# Rehabilitation of Twenty-Seven (27) Public Schools in Lebanon

LRPS 2022-9174996

Q&A

**BIDDERS QUESTIONS - Technical related**  
**All Schools Related Technical Questions:**

PROJ. No.:	L2021-05
DWG. No.:	GA187

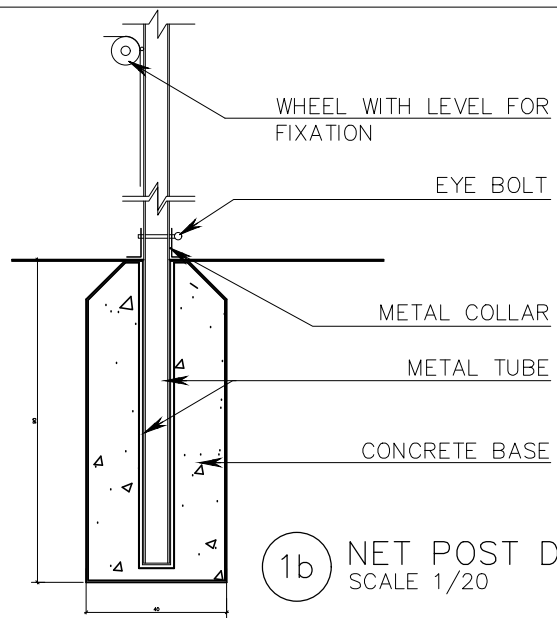
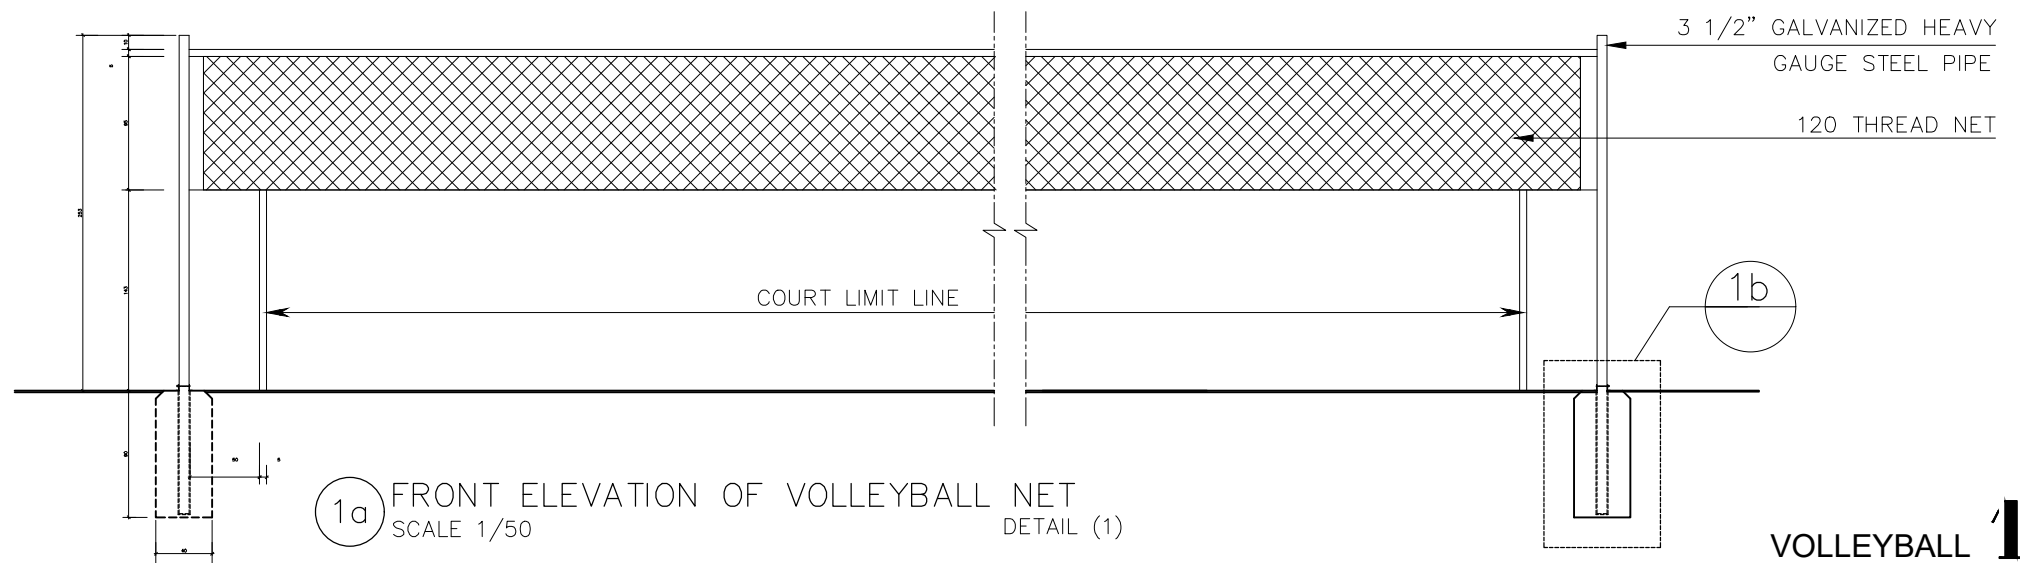
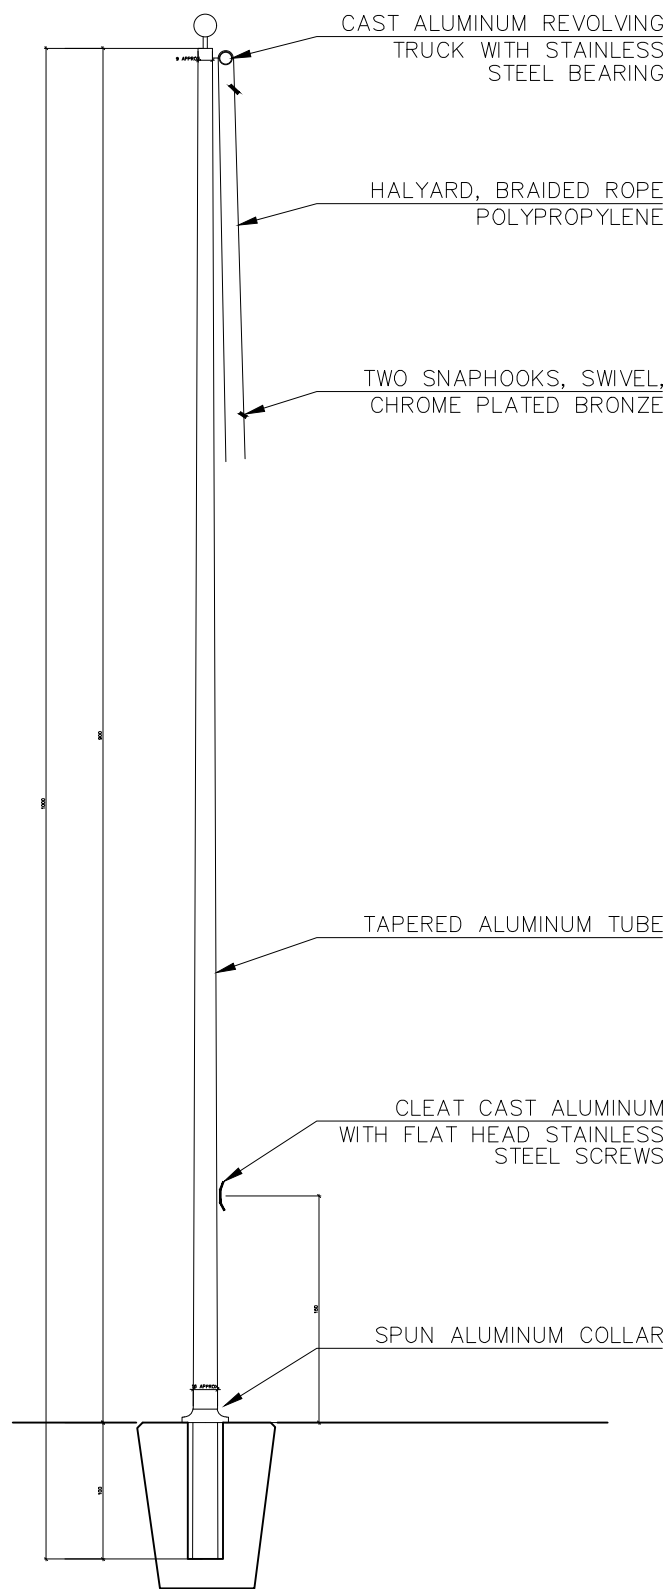
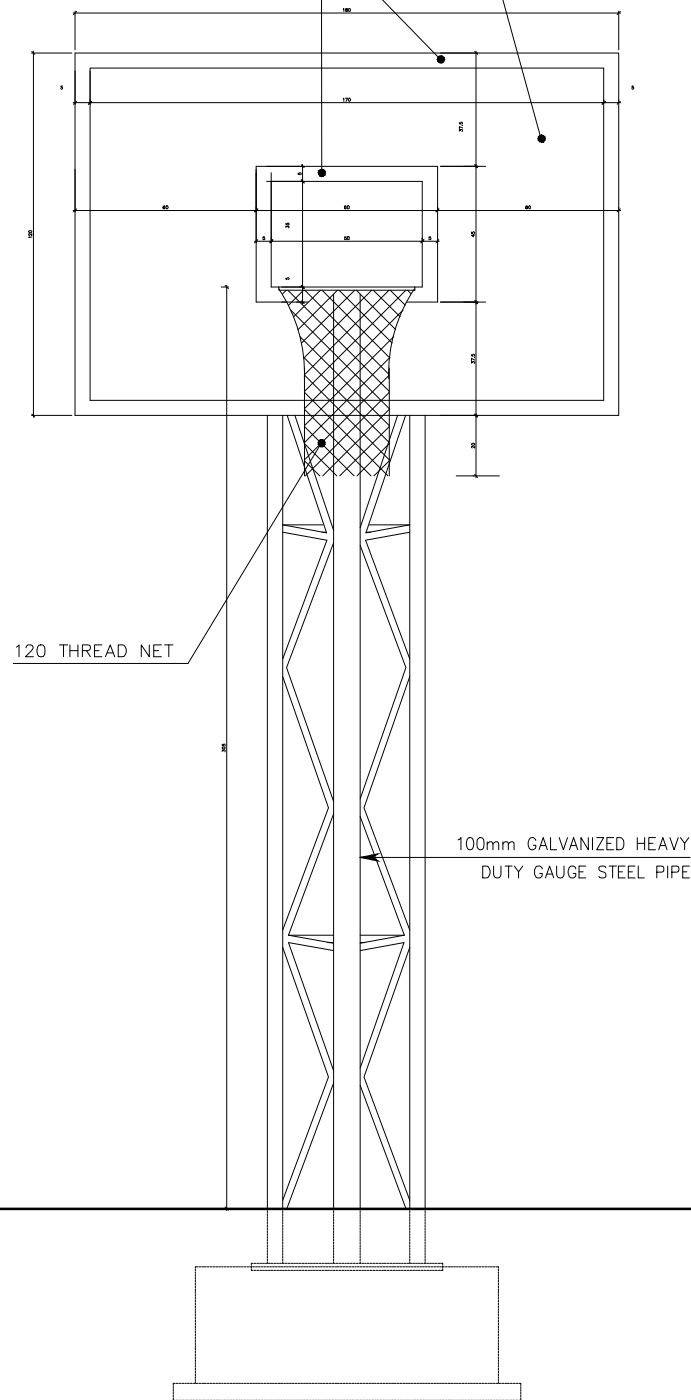
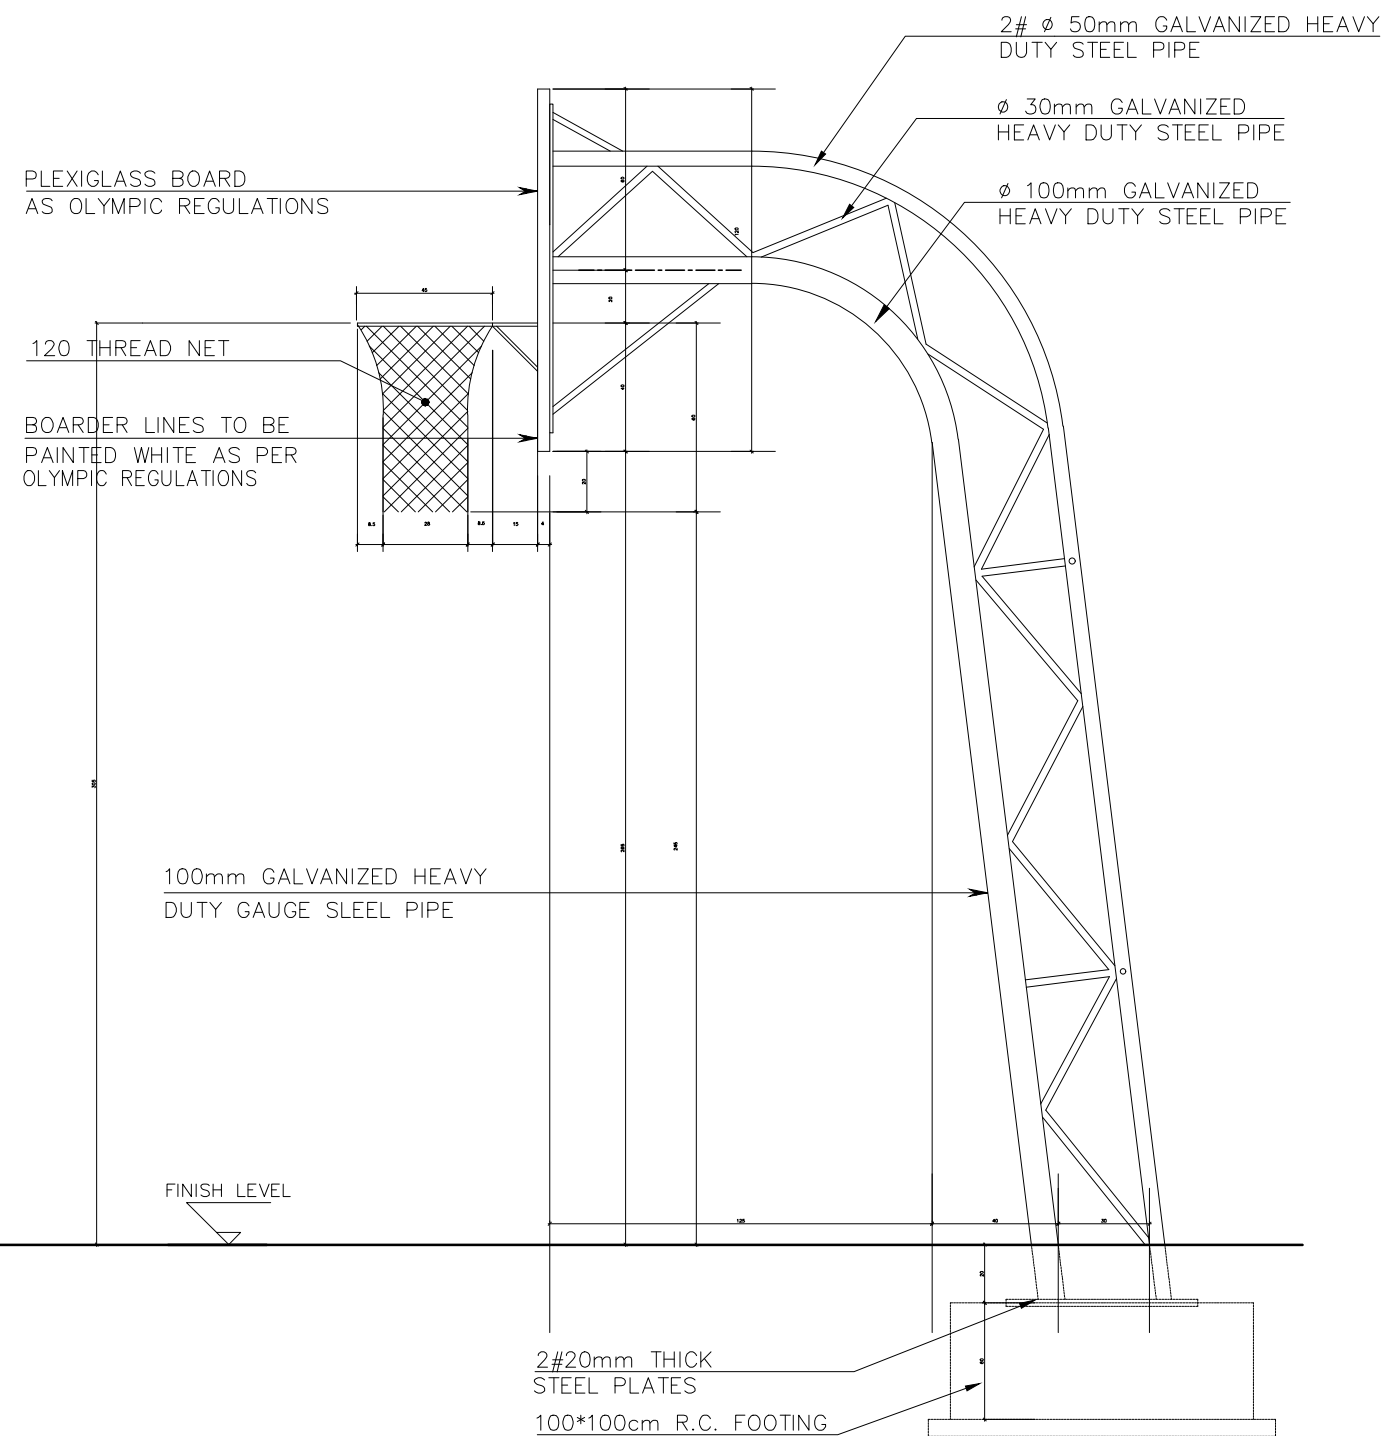
##### b. With reference to BOQ - Part 1 - Civil, Structural and Architectural and Part 4 - Optional Items, item 2.7.2 (Recycling Containers) and item 2.11 (Flagpole). Kindly note that the related drawings to these mentioned items GA186, GA187 and GA188 are not available.

a. It is available in the Market with volume Approx. 1 m3 b. Refer to attached drawings (GA186, GA187, GA188)
14. In many schools (e.g. Maghdoushe) the location of the existing bathrooms is changed, in that case how are you proposing to lay the electrical and mechanical works? exposed/suspended?
Provide hidden installation where applicable (based on roof / walls type and conditions)

PROJ. No.: L2021-05  
DWG. No.: GA188

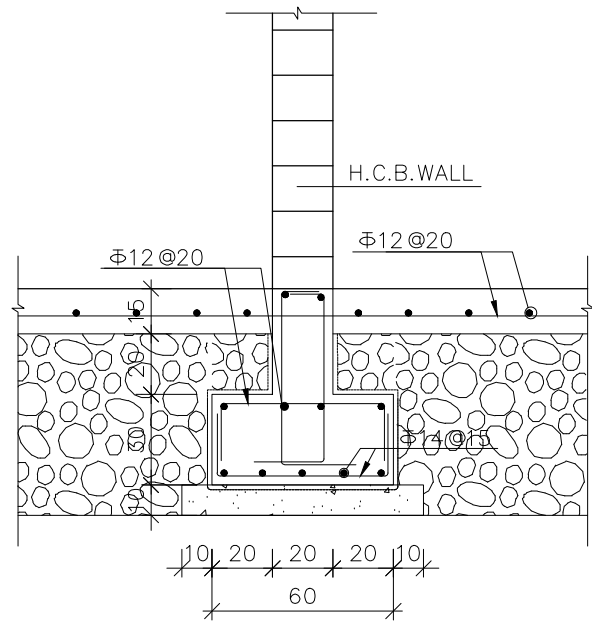
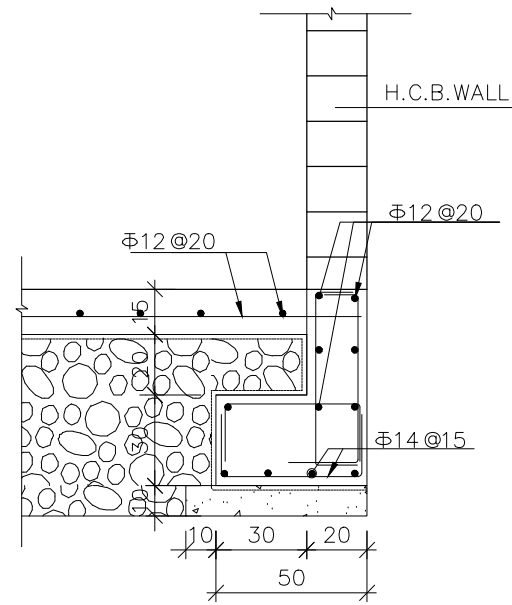
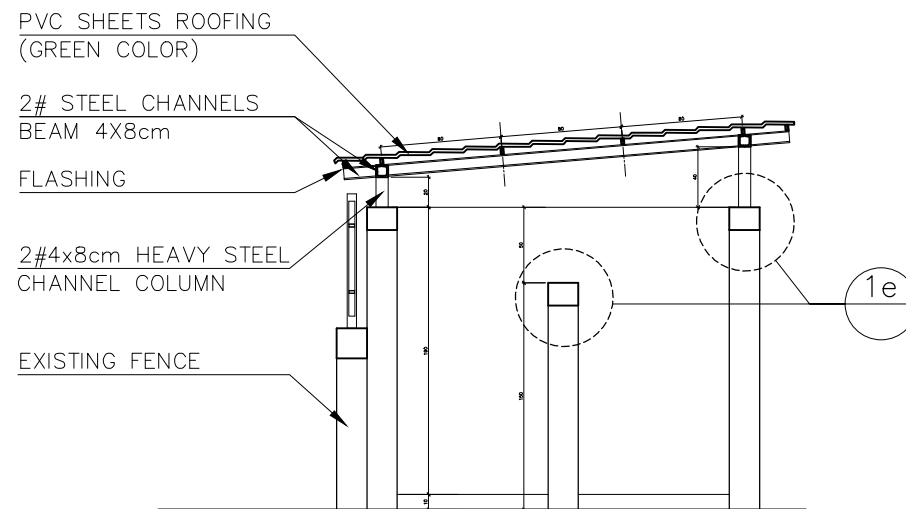
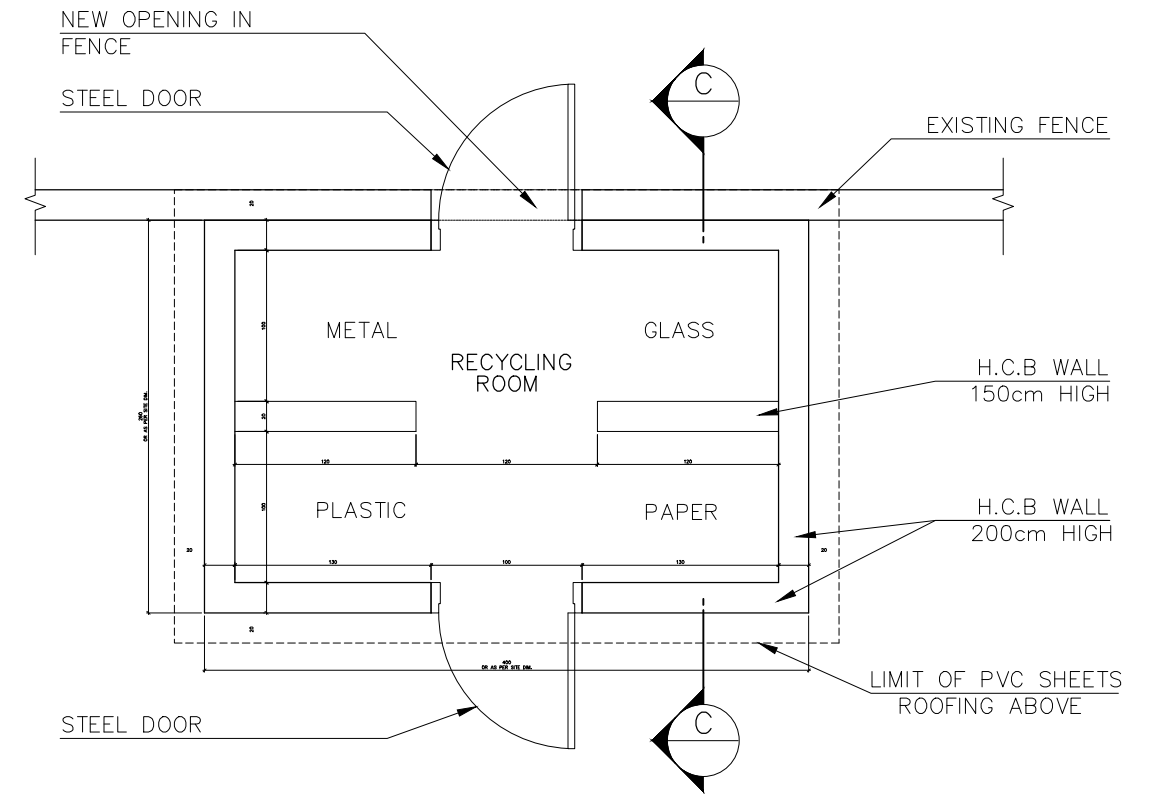
##### a. Please provide us with size/volume for the recycling containers.
